PCD Project Number: PPR2232 & MS232 Unresolved.s

DRAWN BY: O.E. WATTS DATE: 1-29-21 DWG. NO.: 20-5523-05 SURVEYED BY: DEV, ESW, 10-6-20	APPROVED BY: PROJ. NO. DWG.	REVISIONS	PROJECT OLIVER E. WATTS CONSULTING ENGINEER COLORADO SPRINGS FALCON STORAGE PARCEL PART W 1/2 SEC. 1, T.13S., R.65W., 6TH P.M. EL PASO COUNTY	SHEET NO. GRADING AND EROSION CONTROL PLAN 2 OF 4	SHEET NO.
---	-----------------------------------	-----------	---	---	-----------

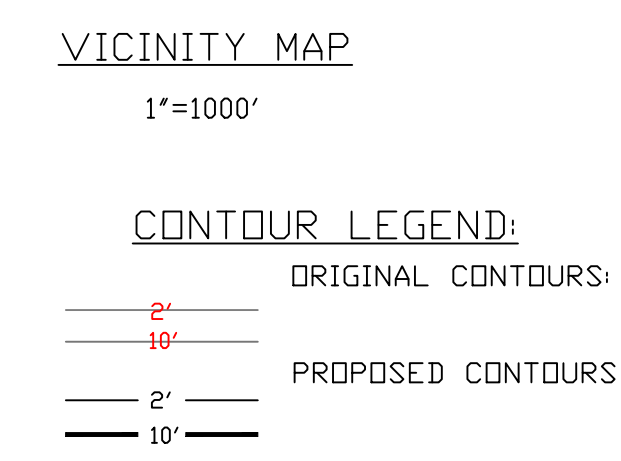
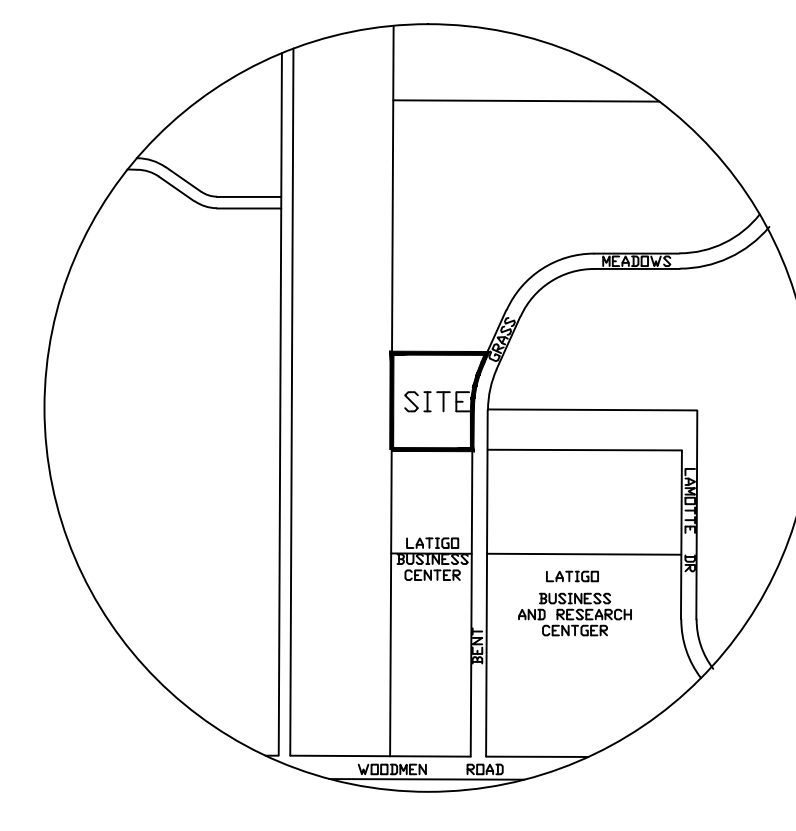
show existing detention basin where flows are being routed to. SWMP states: This project outfalls to an existing detention pond, Falcon Meadows on the south side of Woodmen Road, owned and operated by another entity?

remove red linework as it clutters the plan. Add back the gray outline of the parking areas and identify the surface material for the RV parking spots, if different from the drives

comments have been provided on the TIS to provide recommendations for the radi. Please coordinate with the traffic engineer and adjust as necessary

Clearly label existing contours. unresolved

existing/proposed? to remain? to be removed? unresolved.

The details listed do not match the proposed driveway shown on the plans. It appears that a cross pan is proposed. Please provide the appropriate detail and identify the width of the cross pan. Please revise accordingly.

provide fence or handrail to protect pedestrians on sidewalk

slope drain pipe and filter material towards outlet structure

Please label and provide detail of the proposed PED ramps on each side of the driveway. Identify the cross slope at the pedestrian path at the driveway (2%max)

are you proposing a retaining wall here? provide details

show sidewalk slopes and dimensions of pond

identify the location of the maintenance access to the sand filter basin bottom

call out as TSB, to be converted to a SFB.

i assume this is a concrete rundown. Please provide specifications for this and label it on the plans.

where is flow outfalling?

adjust C/F line to match legend

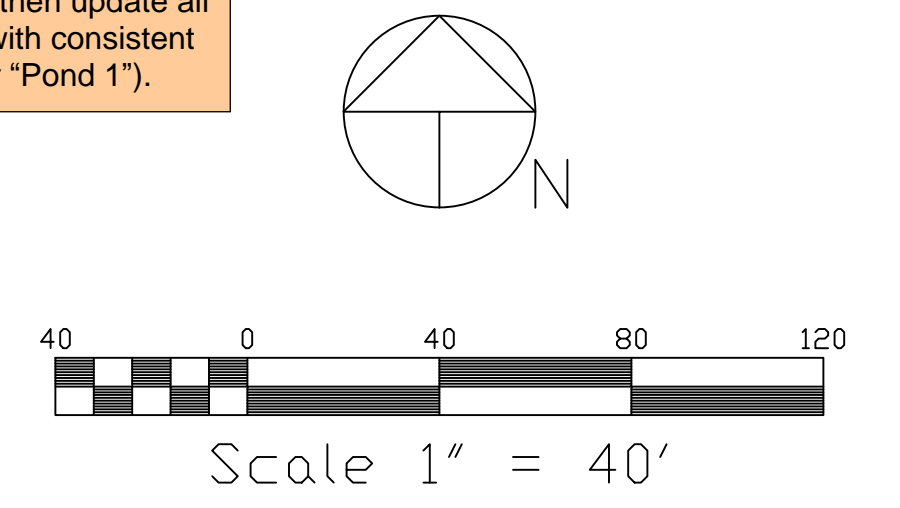
Please see comments on the drainage report regarding the conveyance of flow from the sub-basins to the pond and revise the plan accordingly. Provide spot elevations as needed to show how flow is directed to the pond.

update material

provide inlet protection

flow arrows do not match the contours. Revise

Provide energy dissipation at all inlet points into the sand filter (and calcs in drainage report). Use an impact basin for pipes and a baffle chute or grouted sloping riprap drop if a channel or swale is used, or install a Type VL or L riprap basin underlain with geotextile fabric at the inlet. Fill all rock voids with the filter material specified in Table SF-1.

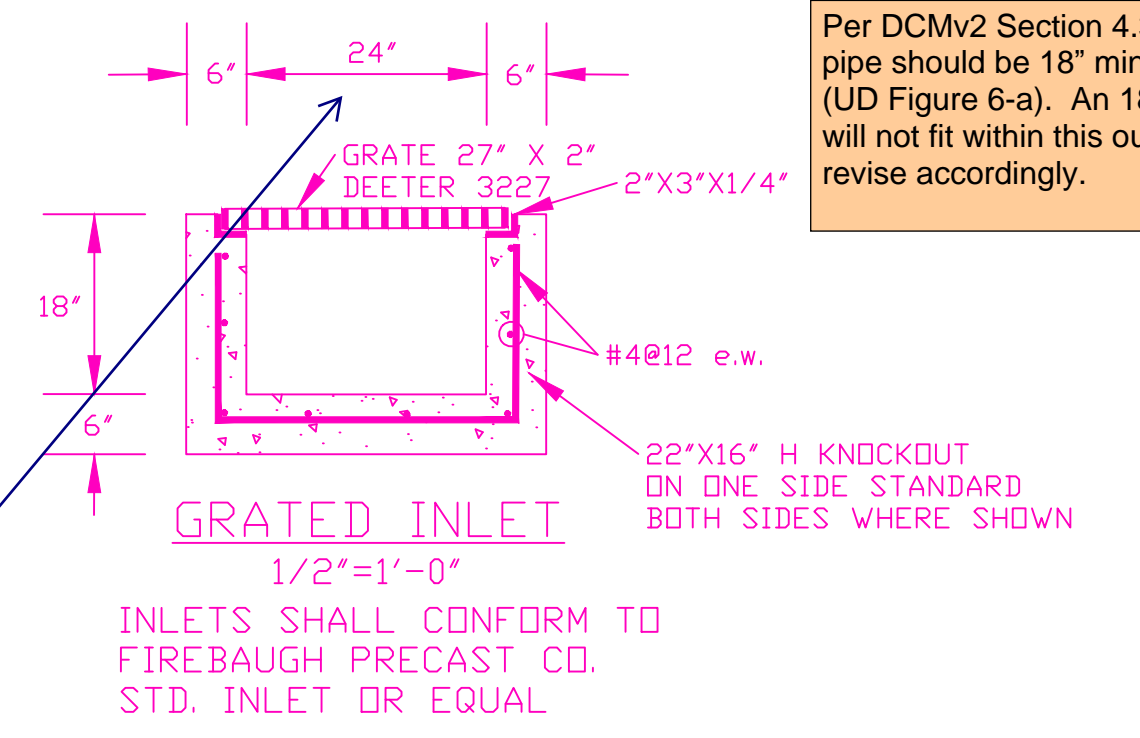
Assign a name/number to all PBMPs and then update all submitted text and drawings accordingly with consistent labeling throughout (example: "Pond A" or "Pond 1").

Final stabilization needs to be shown on figure. Consider creating a separate sheet to show all areas for proposed asphalt, proposed concrete, and proposed seeding/mulching. Unresolved.

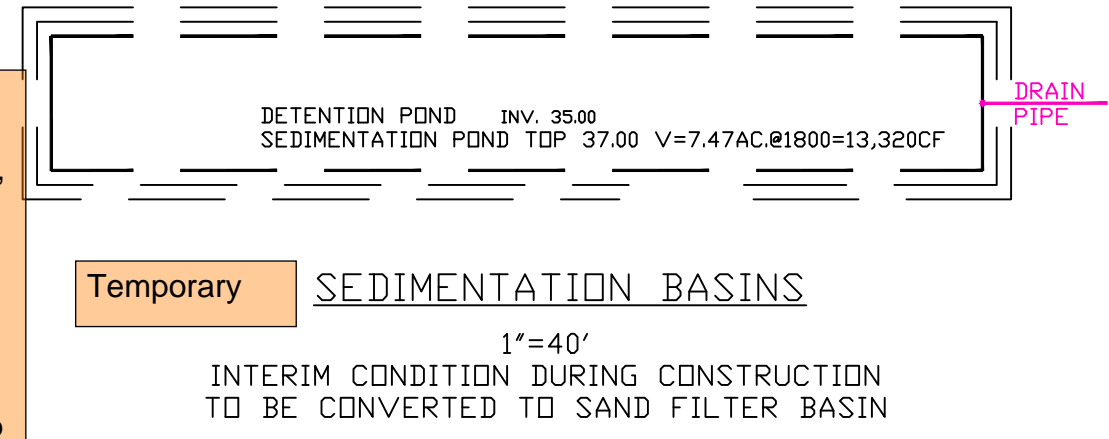
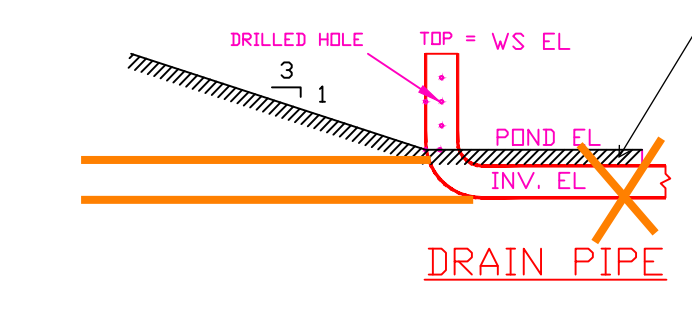
Per DCMv2 Section 4.3, outlet pipe should be 18" minimum. (UD Figure 6-a). An 18" pipe will not fit within this outlet box. revise accordingly.

Limits of disturbance is not the same as the cut/fill line. Adjust accordingly. Unresolved.

adjust phase unresolved.

TSBs collect water in pond and discharge to outfall. adjust drain pipe accordingly

is this for the temporary sediment basin? Provide details of temporary sediment basin including riser pipe diameter and perforation sizing, number of rows of holes, required volume, location of outlet pipe and spillway, and tributary area to the sediment basin. And provide contours for sediment basin.

Provide construction details for SFB. Including elevations, WQCV/EURV/100YR elevations, pipe length and elevation, orifice hole sizes and elevations, detail for outlet structure pipe penetration (including location, slope, and elevations), spillway details (including elevations, storm elevations, material, riprap gradation, slopes), clean out, concrete rundown details, filter material, etc etc.
